UNITED STATES PATENT AND TRADEMARK OFFICE

10/599,990

Office Action Summary	Application No. 10/599,990	Applicant(s) BAKER, KEITH	
	Examiner Nathan A. Danielsen	Art Unit 2627

DETAILED ACTION

*Fig. 2a*

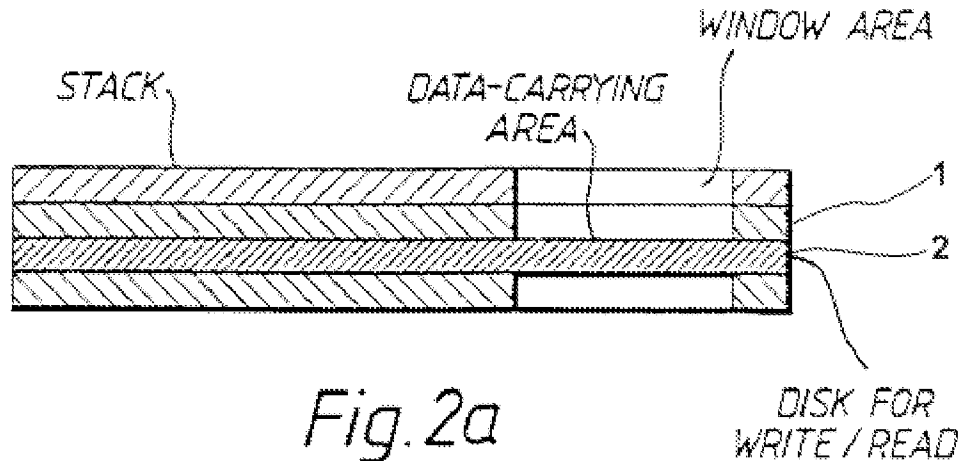
Regarding claims 1 and 10, Gudesen discloses an optical data storage medium (figure 2) comprising:

a first disc (element 1 in figure 2a, as shown on the next page) and a second disc (element 2 in figure 2a, as shown on the next page) both having an access surface (the surface of element 2 exposed to the optical read/write device of col. 5, line 67 through col. 6, line 1 on the side of the data carrying area from which light is irradiated by the optical read/write device) and a storage layer covered by the access surface (col. 6, lines 25-27), wherein the storage layer is adapted to be accessed by a laser beam via the access surface (implied by the structure disclosed in col. 6, lines 30-39 in that “high area density for the storage” would require the use of “sharp focusing of a laser beam” (see col. 1, line 65 through col. 2, line 2)), characterized in that the first disc and the second disc are adapted to be attached to each other in such a way that the access surface of the first disc covers the access surface of the second disc (the surface of element 2 “covers” the surface of element 1, as shown on the next page, where “cover” has been interpreted to mean “to hide from view; screen”
